Submitted by the expert from the European Commission

Informal document GRB-65-09
(65th GRB, 15-17 February 2017,
agenda item 5)

Proposals for amendments to Regulation No. 63

This informal document was prepared by the expert from the European Commission to complement the proposals in ECE/TRANS/WP.29/GRB/2016/7. It contains additional amendments related to powered cycles. The amendments are related to the definitions and to Annexes 3 and 4.

Figure 1: Measuring positions for vehicles in motion

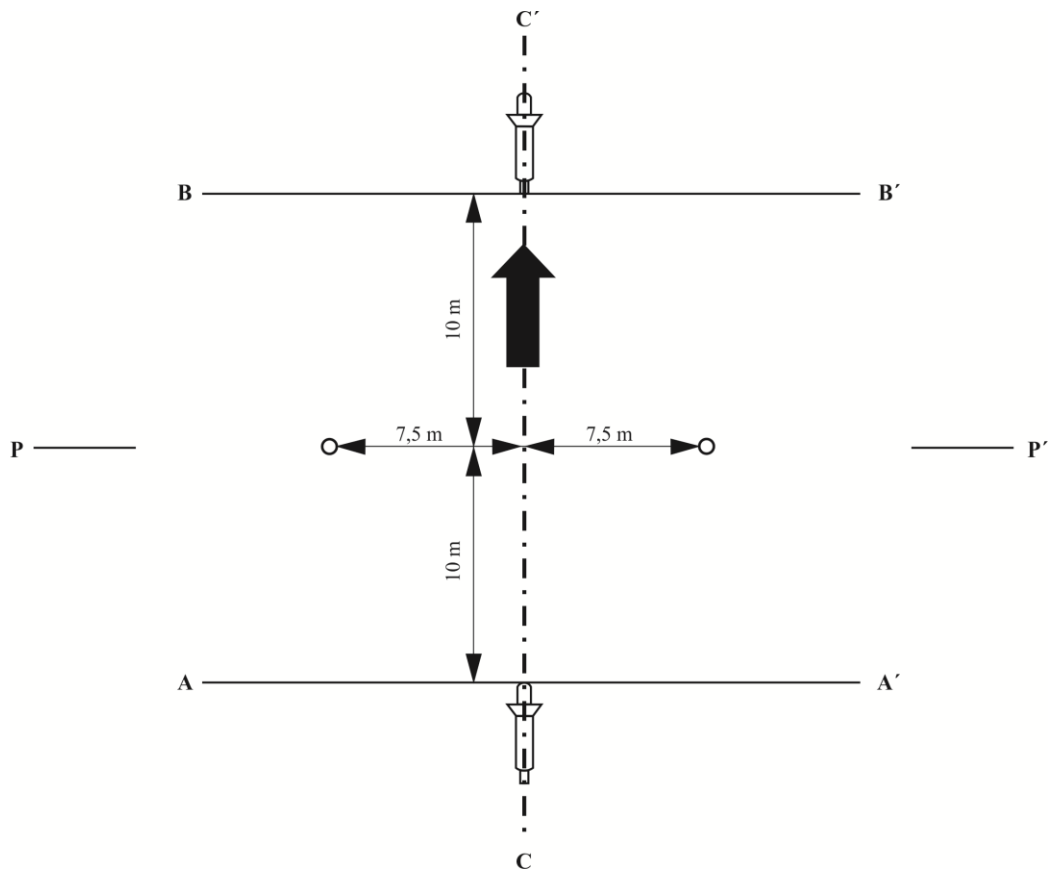
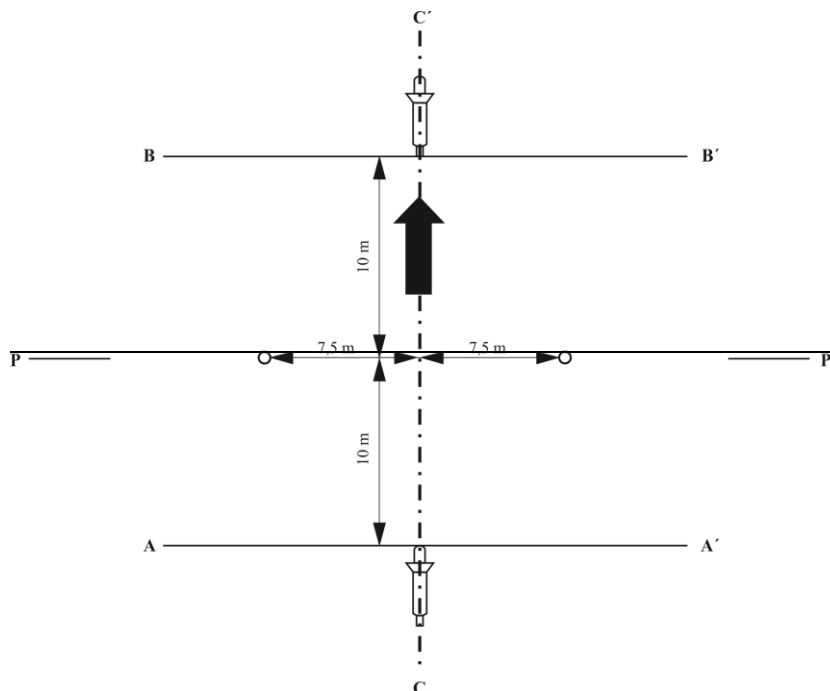
The header 3.1.1 “General conditions of test” was replaced by “Test arrangement and microphone positions”. Figure 1 was moved from the current position to this paragraph.

3.1.1.1. **The test arrangement is shown in figure 1.**

Figure 3: Reference point

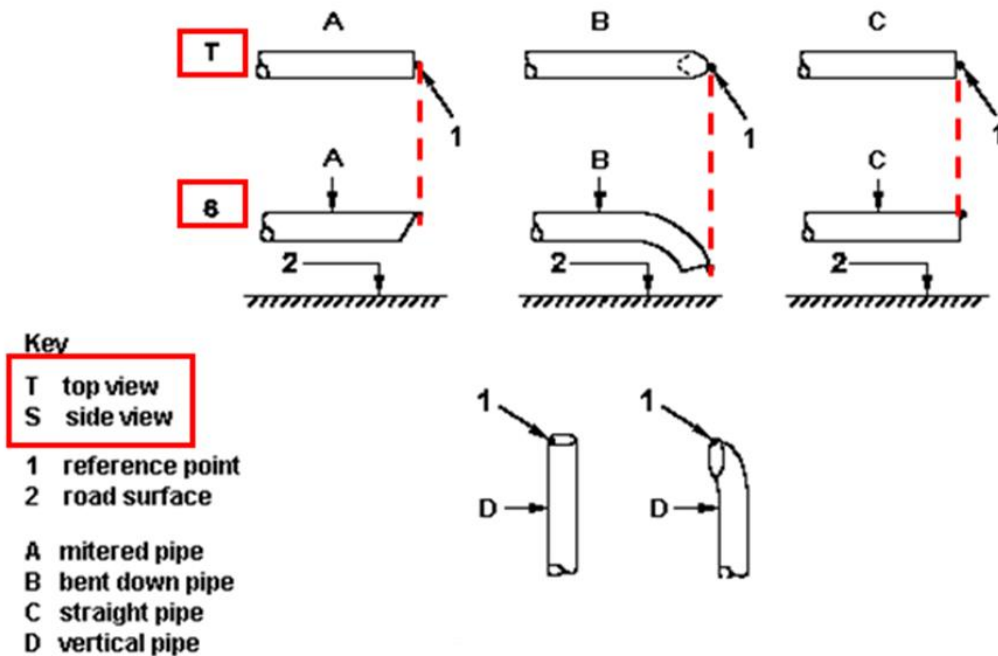
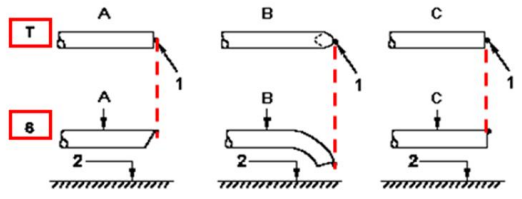
Figures 2 and 4 were moved from the current positions to this paragraph, because they belong to this paragraph. Figure 4 was renamed to figure 3 in order to ensure the right rank order.

The microphone shall be located at a distance of 0.5 ± 0.01 m from the reference point of the exhaust pipe defined in ~~figure 4~~ figure 3 and at an angle of $45^\circ \pm 5^\circ$ to the vertical plane containing the flow axis of the pipe termination. The microphone shall be at the height of the reference point, but not less than 0.2 m from the ground surface. The reference axis of the microphone shall lie in a plane parallel to the ground surface and shall be directed towards the reference point on the exhaust outlet.

Figure 4: Test apparatus for conditioning by pulsation

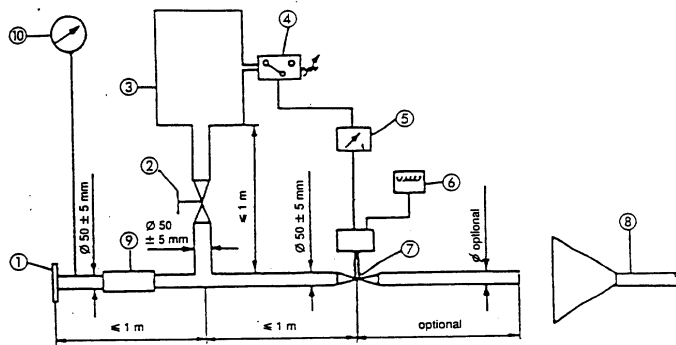
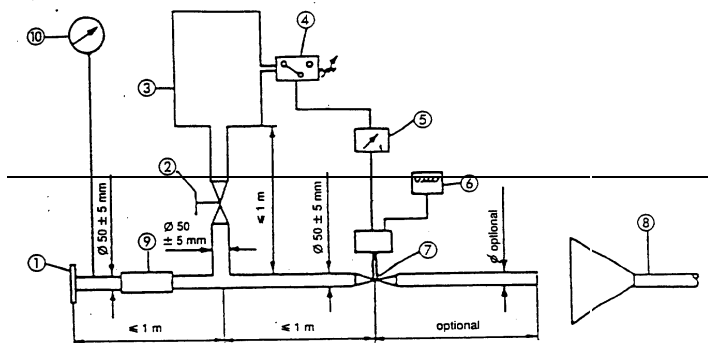
Figure 3 was moved from paragraph 5.3 to this paragraph, where it belongs to and was renamed to figure 4 in order to ensure the right rank order.

- The test apparatus, a detailed diagram of which is shown in ~~Figure 3~~ **figure 4**, shall be fitted at the outlet of the exhaust system. Any other apparatus providing equivalent results shall be acceptable.
